July 11th Design Review – Hearing II

BLOCK A DESIGN REVIEW HEARING 07/11/2013

south elevation (hassalo)

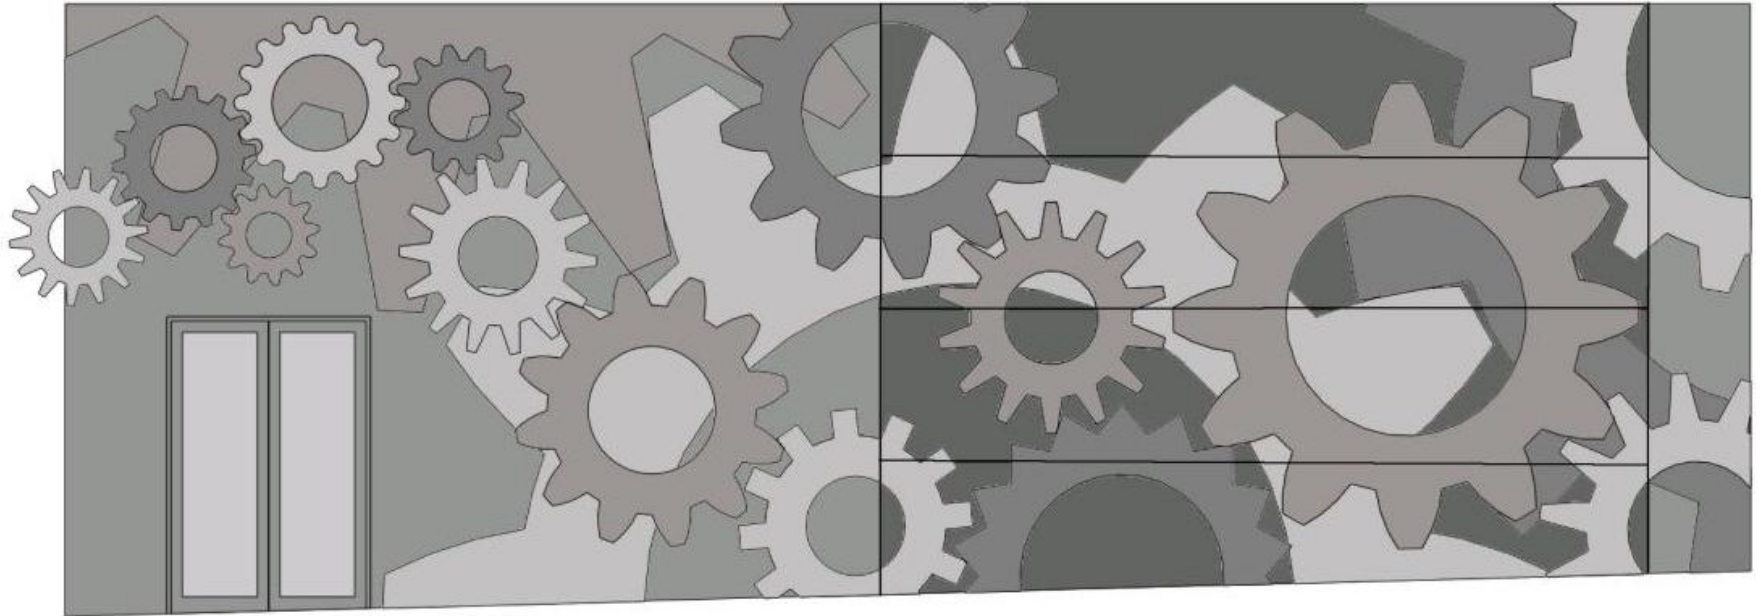
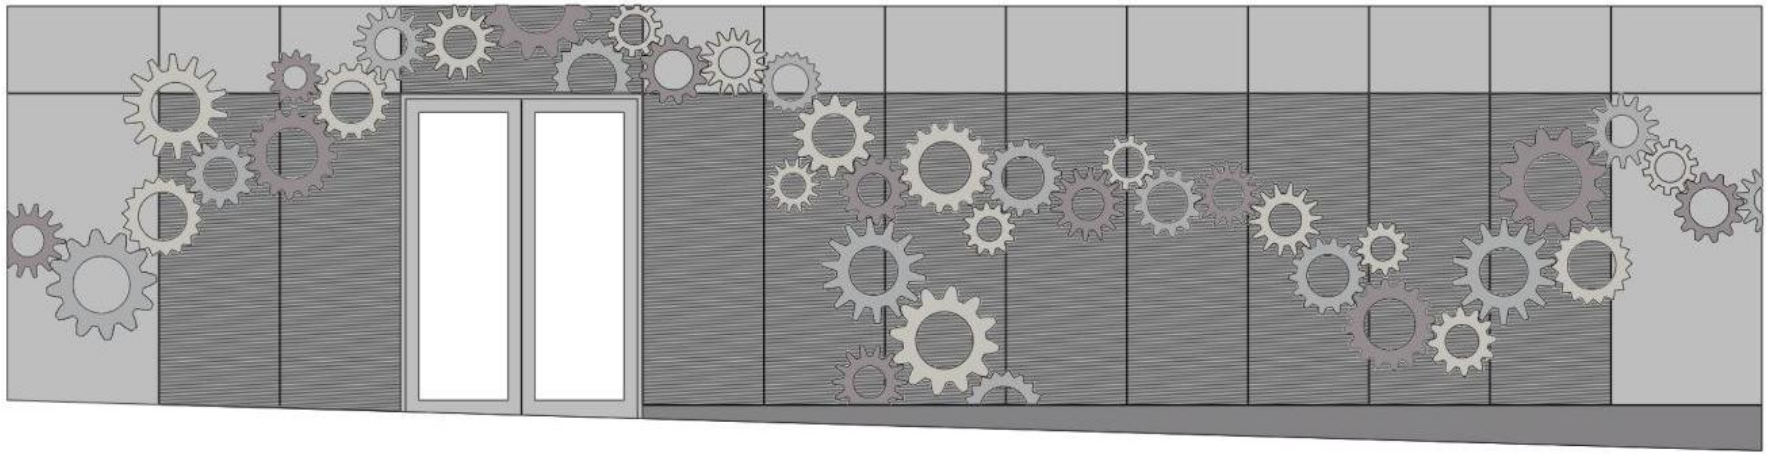
ART

* We have engaged Pete Beeman, a local artist to provide textured stainless steel art pieces at the east edge of the north façade and the south wall at the garage entry.

looking nw (hassalo & mlk)

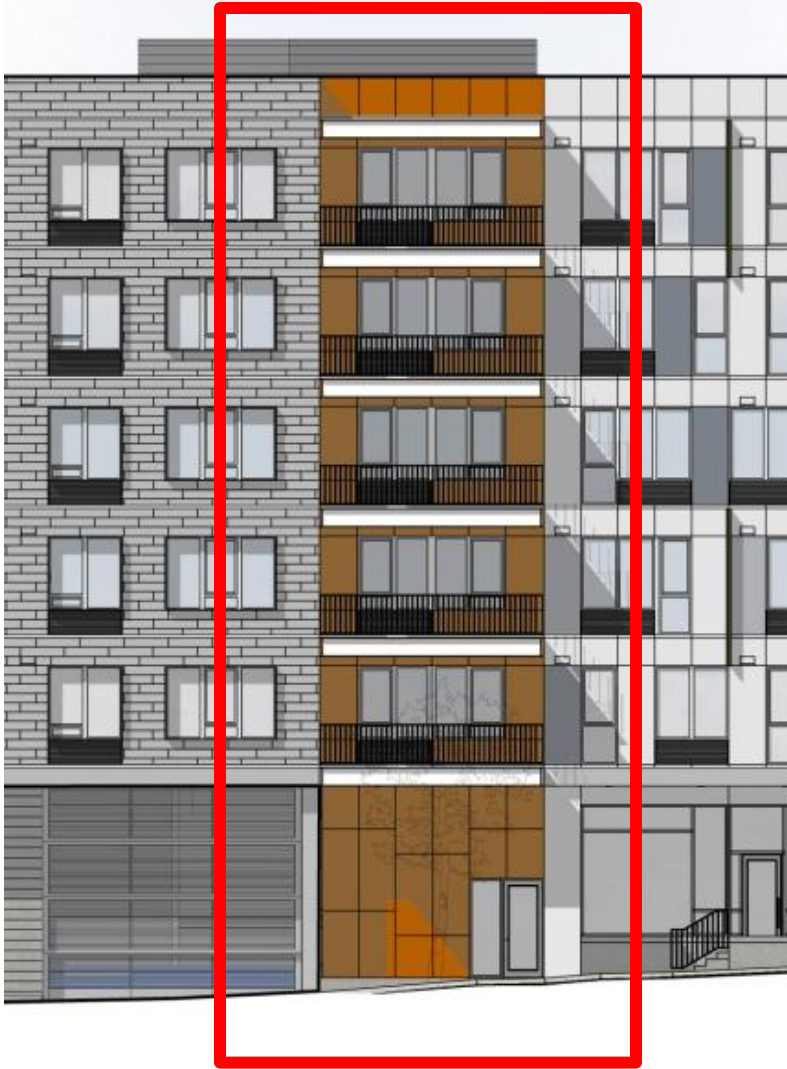
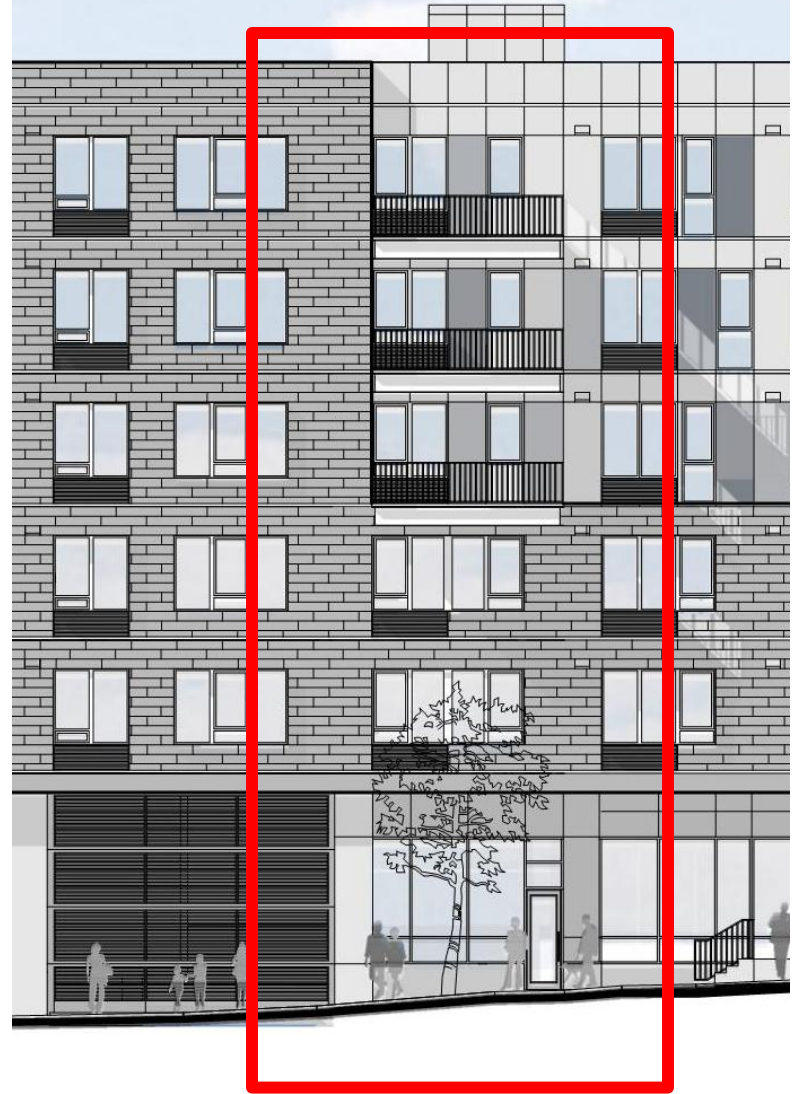
GARAGE ENTRY STAIRS / ORANGE WALL

* Clear storefront glazing has been added to the garage entry stairs to reveal interior activity and provide more consistency with the ground level elements. The orange accent break has been removed.

COMMERCIAL USE AT THE PRIVATE DRIVE (3RD)

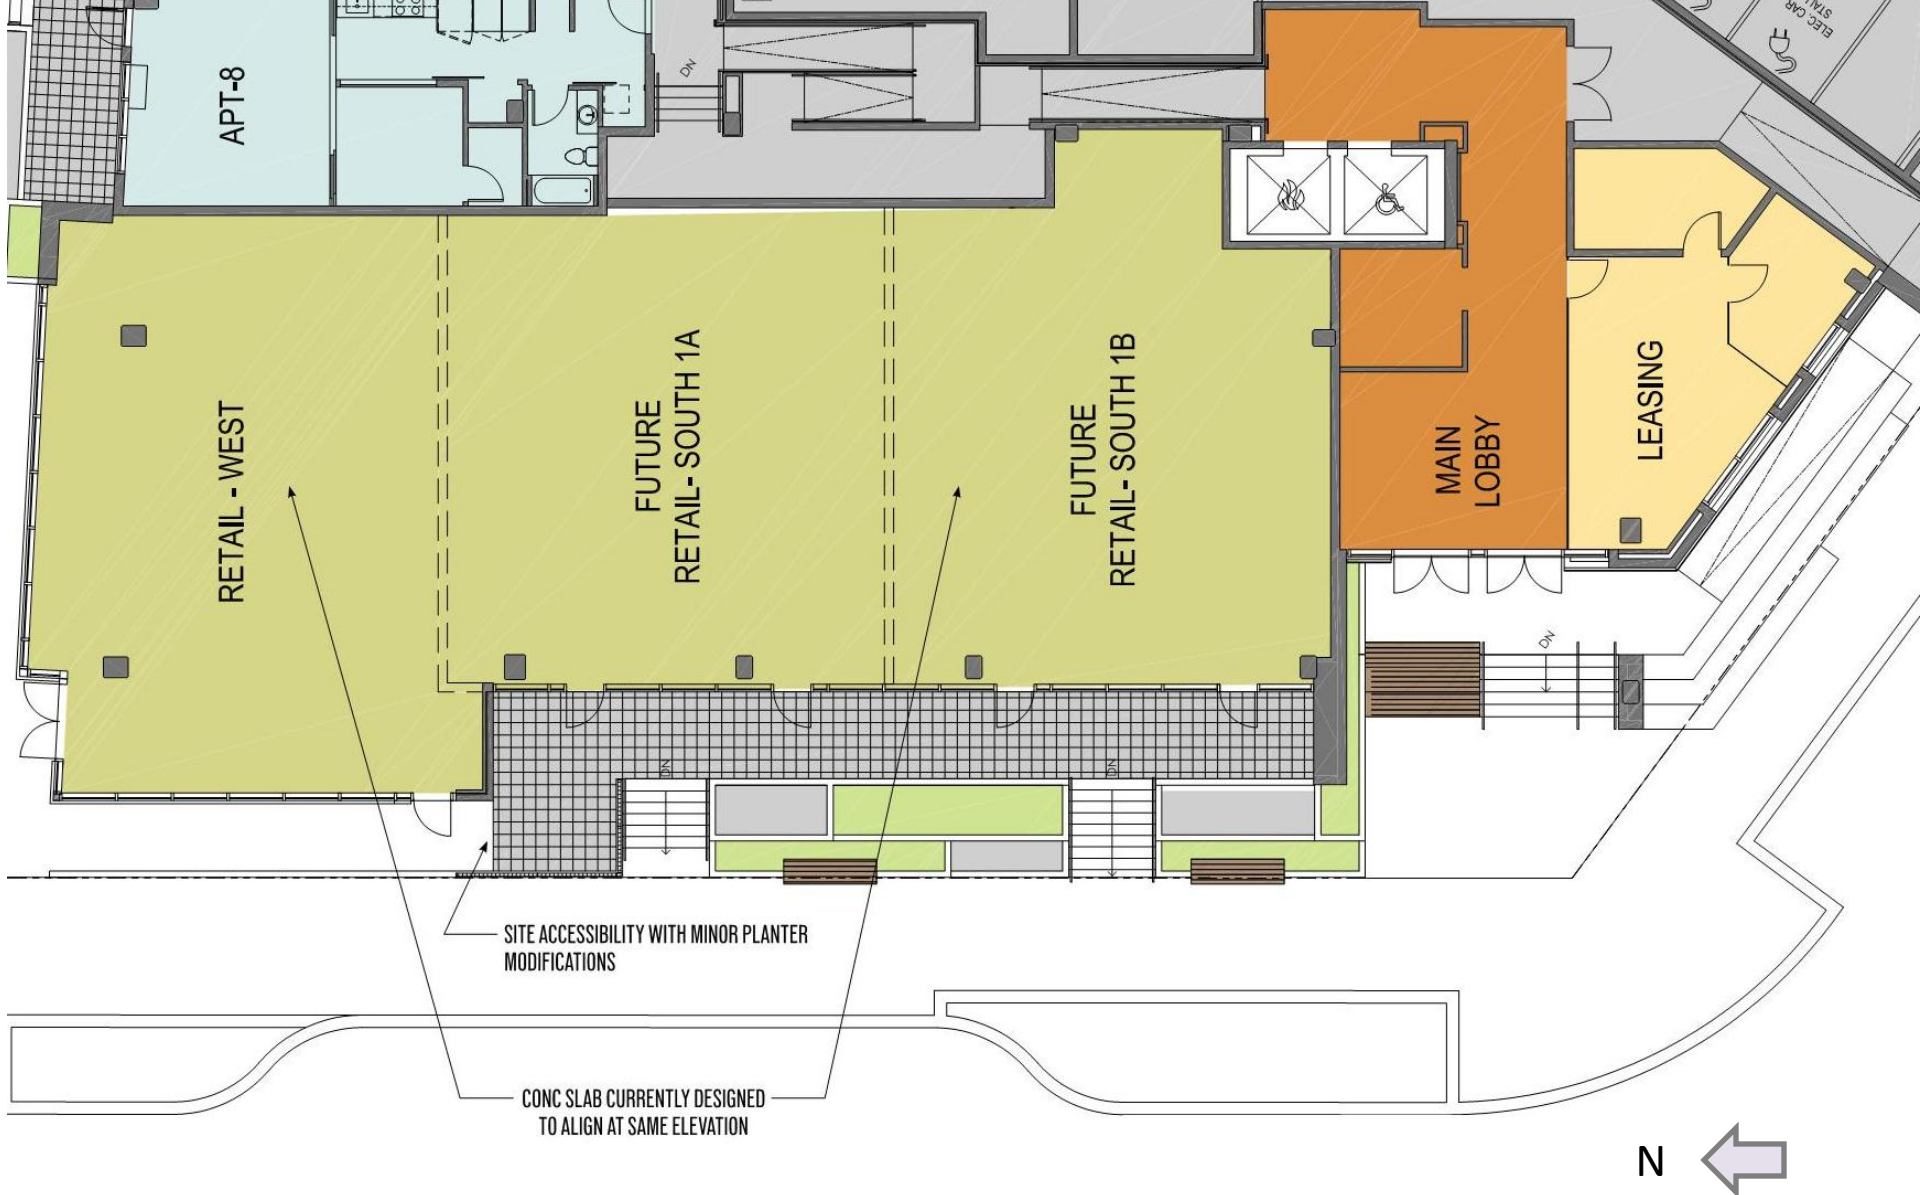
*The residential units along third can be easily converted into retail space.

NORTH ELEVATION

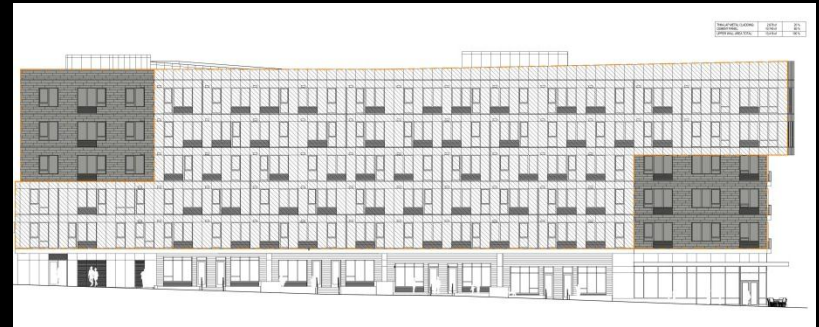
1. “Brave to use Hardie. We need to let this product develop.”
2. “Show the percent of each exterior element used. Hardie should not be the majority.”

1. “Show the percent of each exterior element used. Hardie should not be the majority.”

north elevation (multnomah)

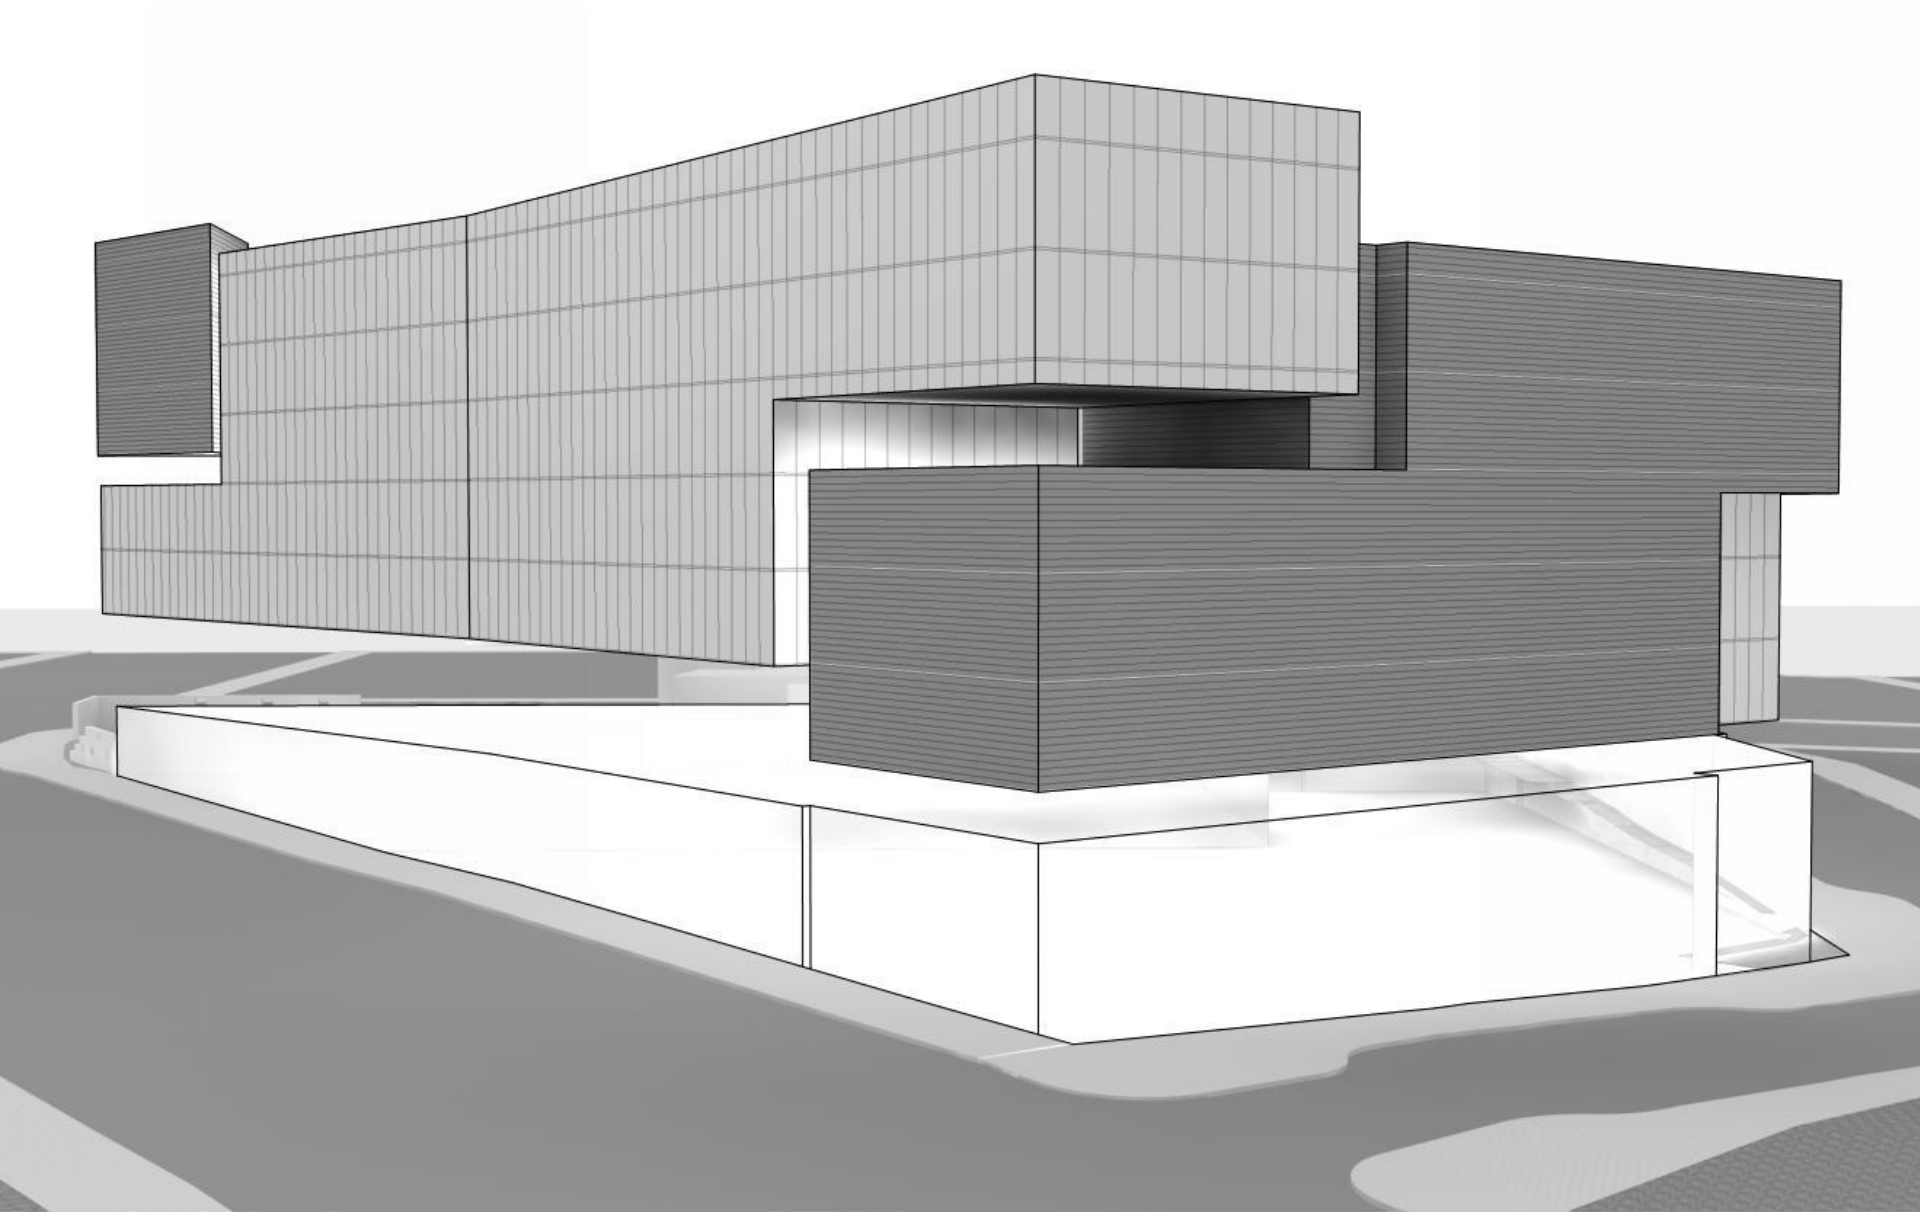
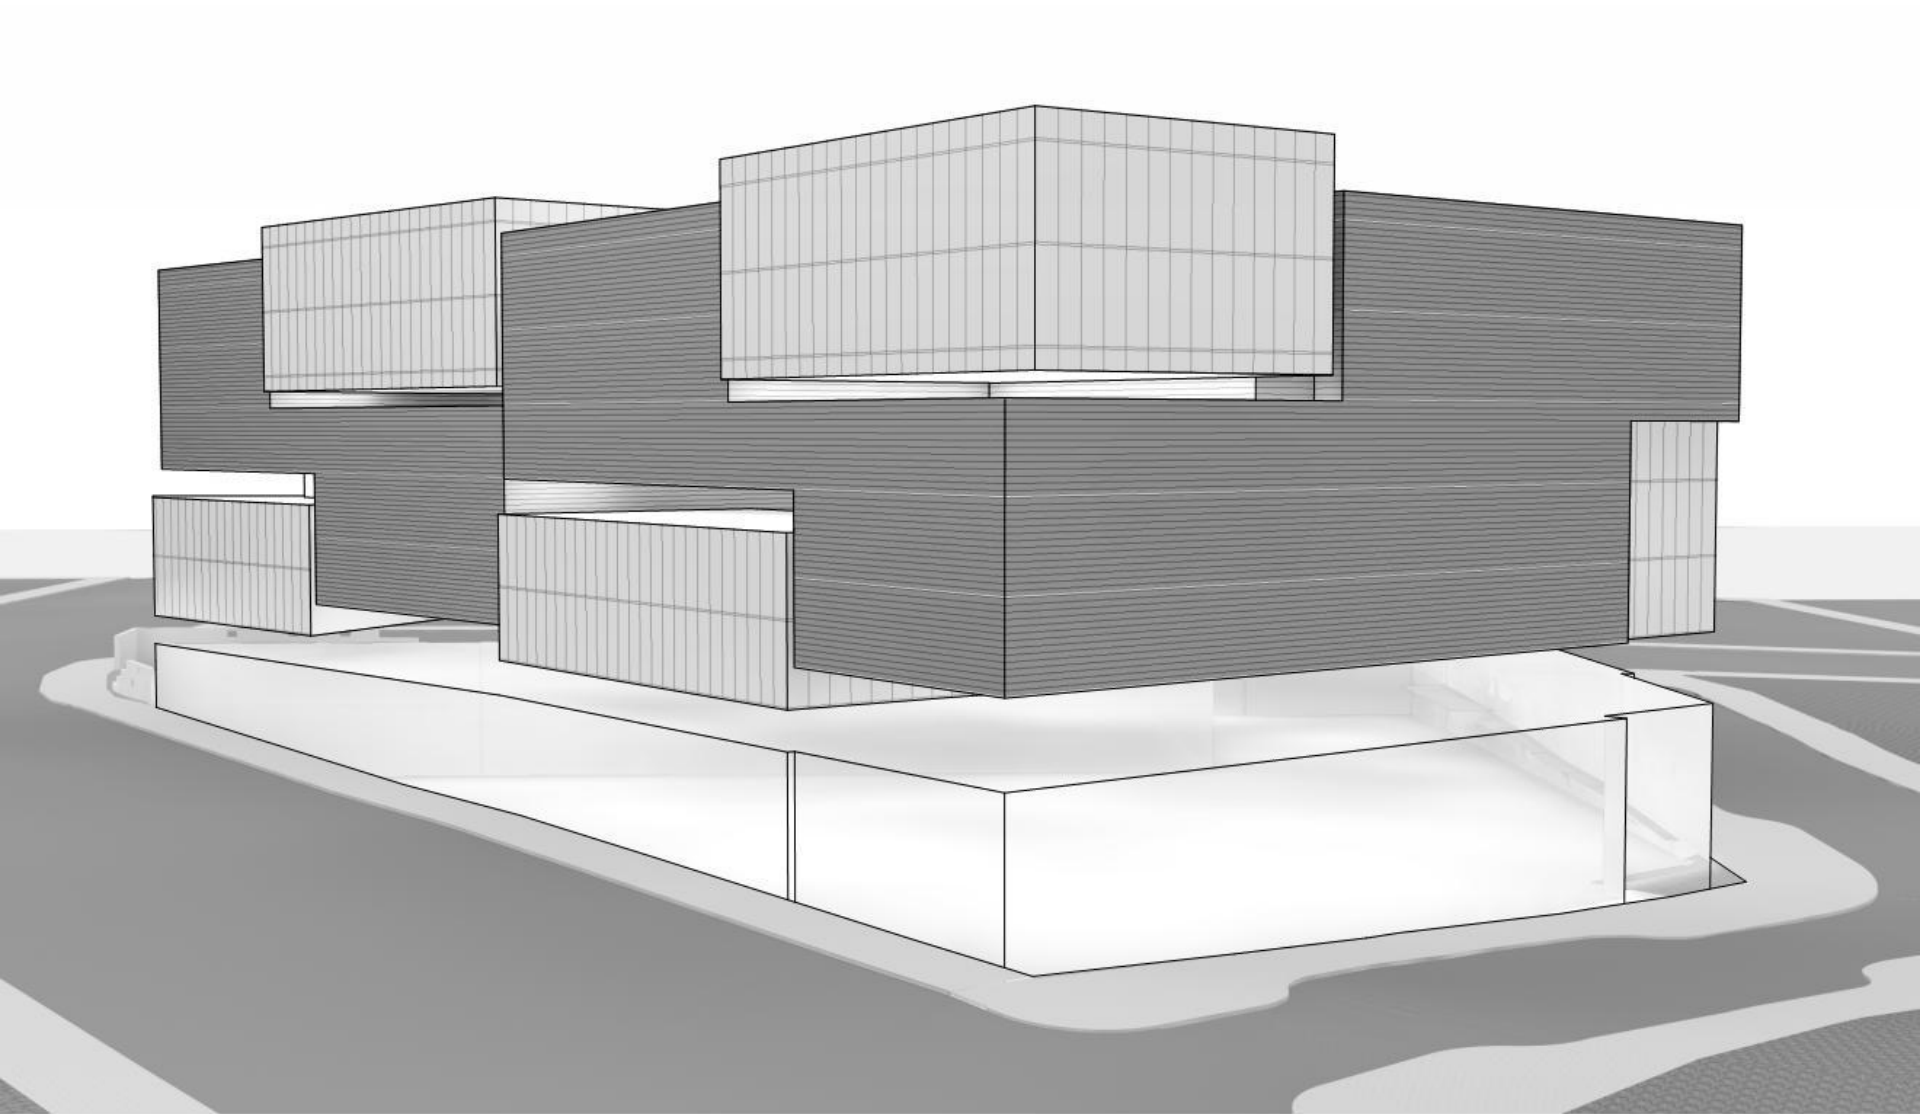
1. “Can the South elevation be more like the north?”
2. “Quality and Design Coherency – love it.”
3. “Massing is interesting and the north elevation is the nicest.”
4. “Like the cantilever and decks on the NW corner.”
